TRO10032 LOWER THAMES CROSSING
COMMENTS ON APPLICANT’S SUBMISSIONS AT D8
For Deadline 9 (11th December 2023)

SHORNE PARISH COUNCIL (IP ref 20035603)

Applicant’s referenced Interactive Map

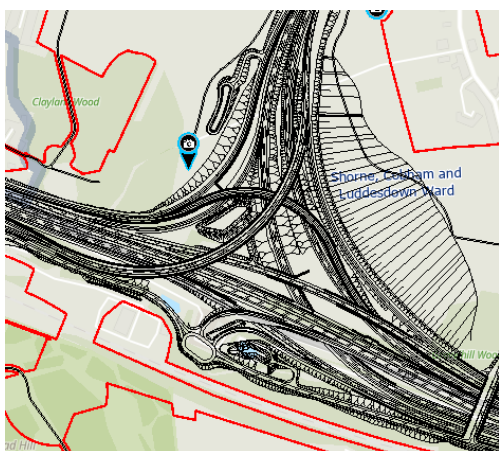
- Response to Mr Brace:
 - If Mr Brace lives 360m from the “alignment of the road” it is understandable that he is upset by the proposals.
 - We understand alignment to mean the centre line of the road, in which case distance to the edge of the carriageway or the edge of the cutting is a lower figure.

- Regarding the Interactive Map, persons who are not very computer literate might have difficulty using the measurement tool although it is good once understood.

- Using the tool shows that some properties in Shorne West are located less than 100m from the centre of the carriageway.
 - We were however interested in the photomontage viewpoint shown below, which is the only one looking at the A122:A2/M2 junction in Operation. This does not seem to be a very good representation of reality, and would have been actively misleading, as proved by the third extract, which is from REP7-189 albeit looking from a greater height, the other direction and not showing the proximity of residential properties.
